BID/ RFP ADDENDUM No.2
DATE: 08/16/2023
BID/RFP No: 2022-19
BID NAME: Vocational Building Remodel

ADDENDUM NO. 02

CAREER TECHNICAL EDUCATION BUILDING RENOVATION
Merced, CA

The following additions, deletions, and revisions to the SHEETS and Project Manual are hereby made and do become a part of these Contract Documents.

AD2-MX01

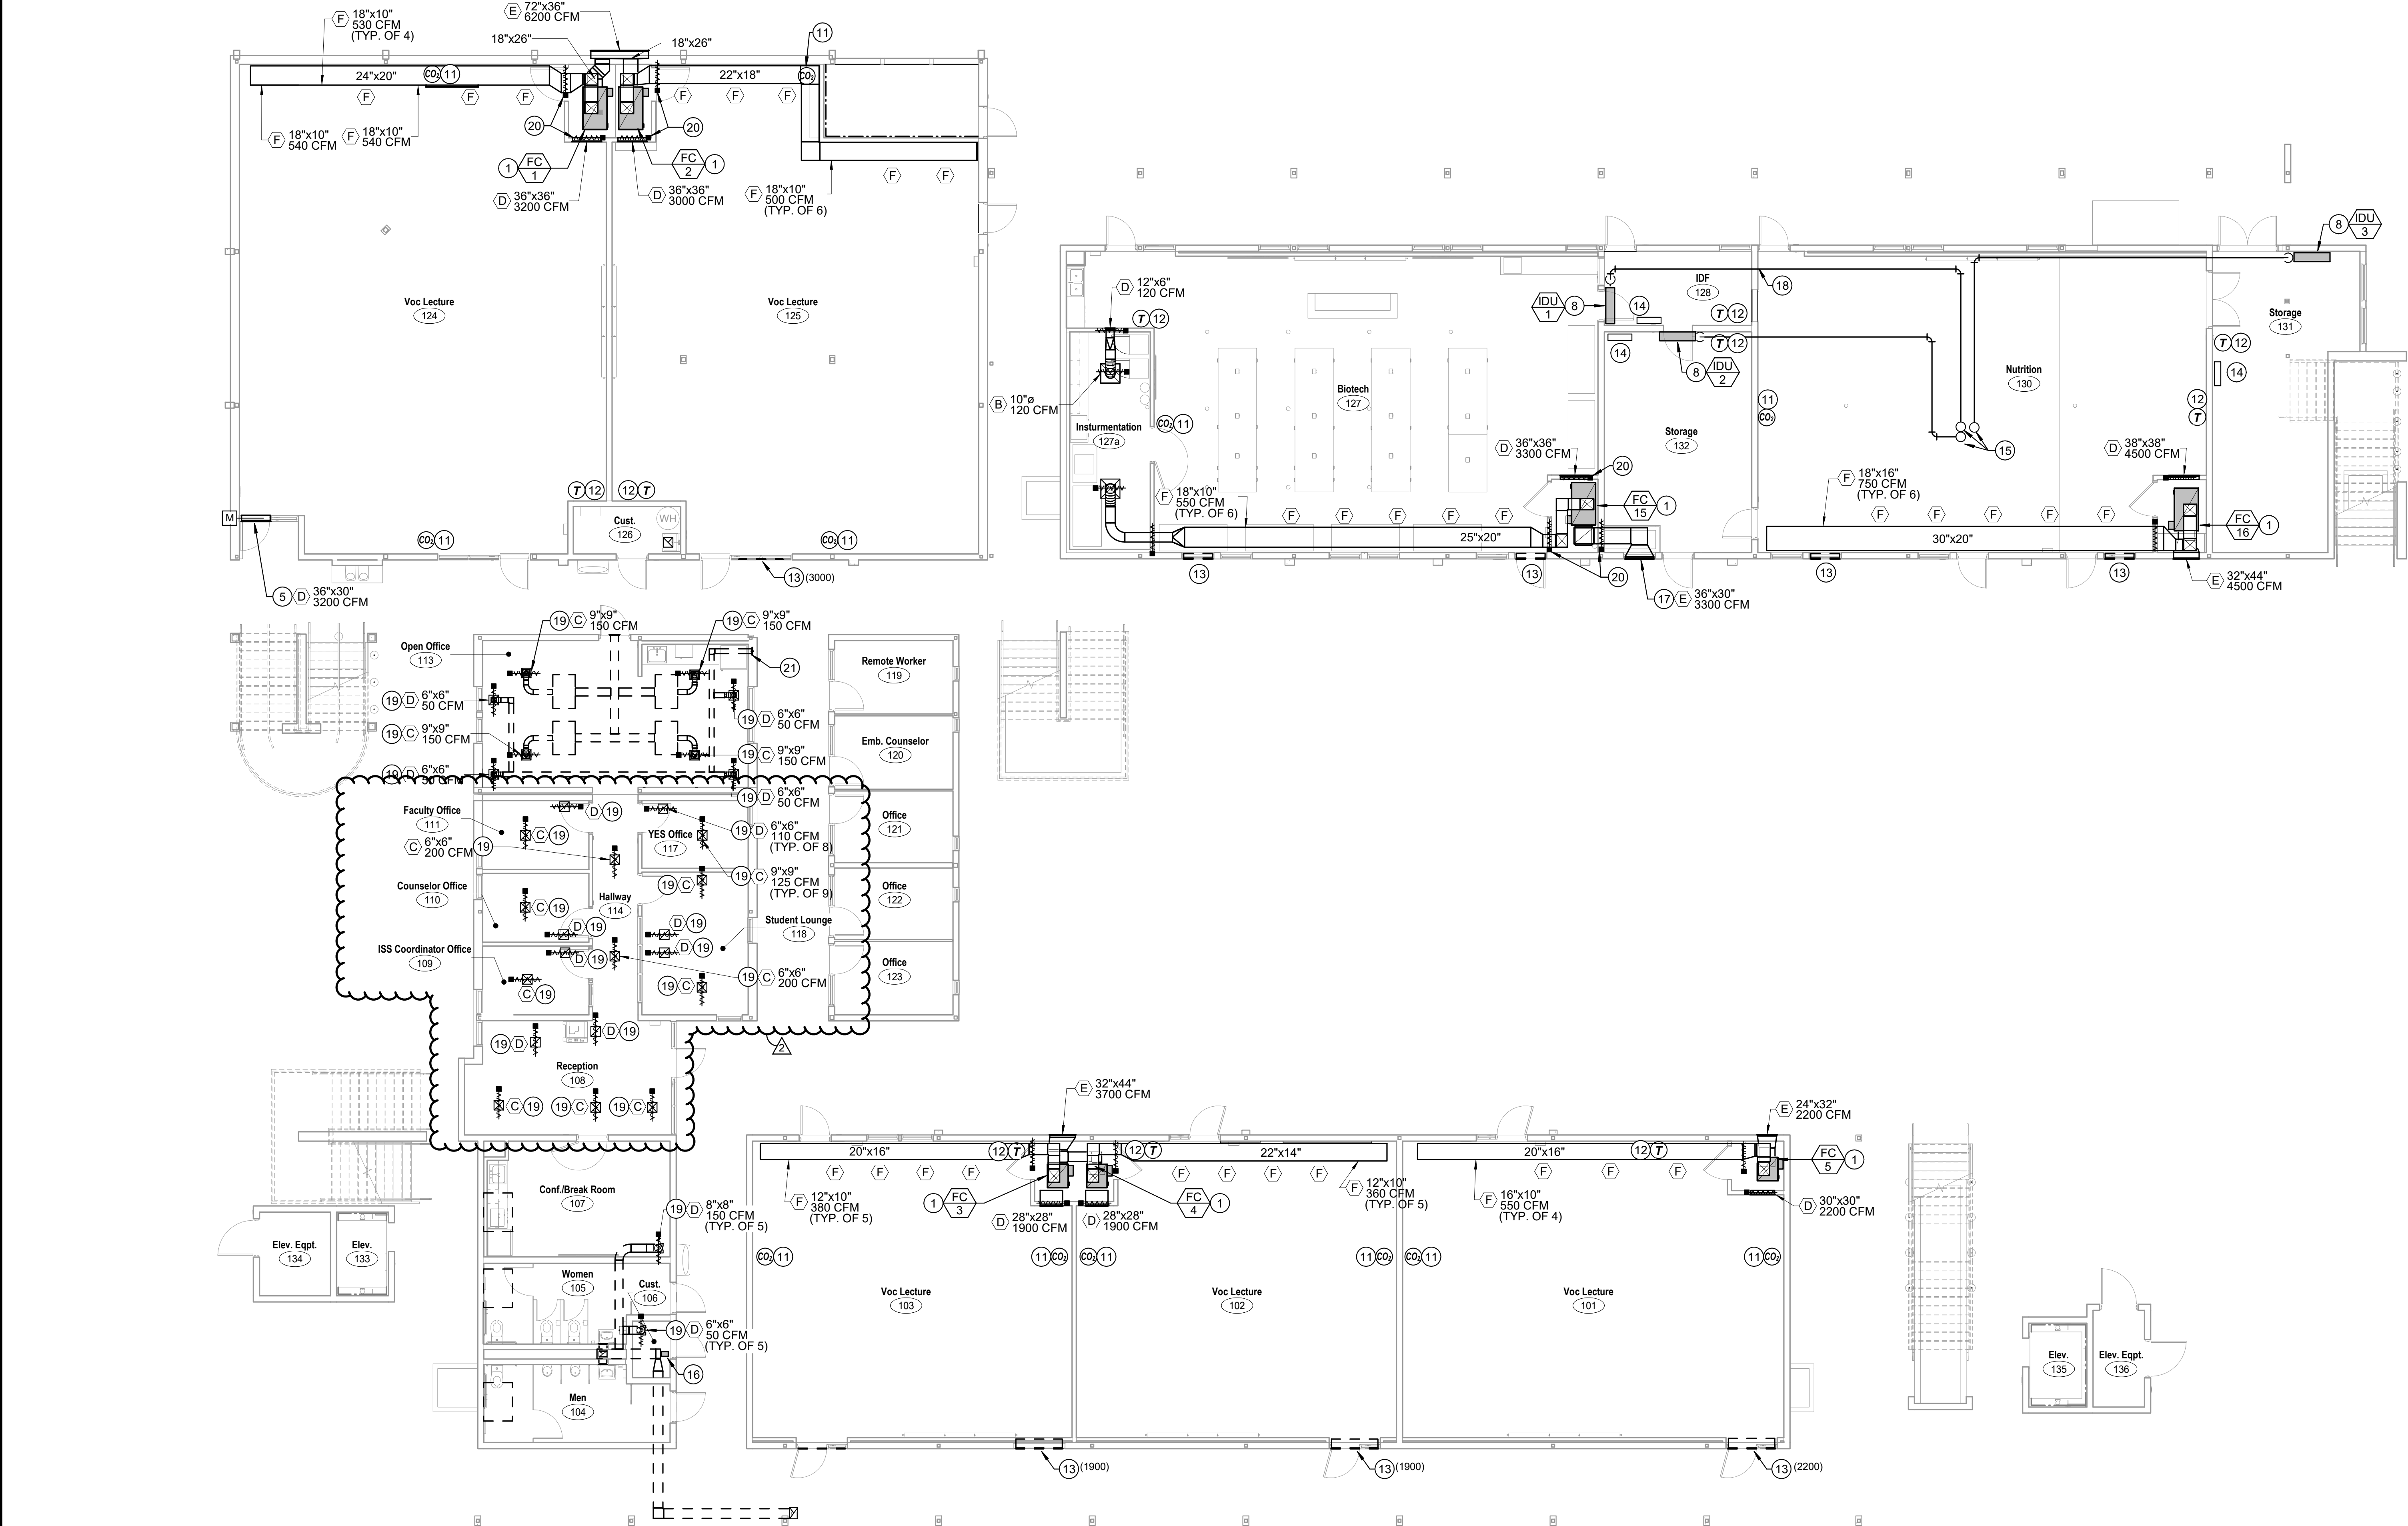
AD2-M01 Refer to Sheet X/M102, MECHANICAL SCHEDULES:

2. Replace sheet with attached sheet X/M102 MECHANICAL SCHEDULES with AD2-MX01 in the lower right corner. Changes are in the clouded area(s).
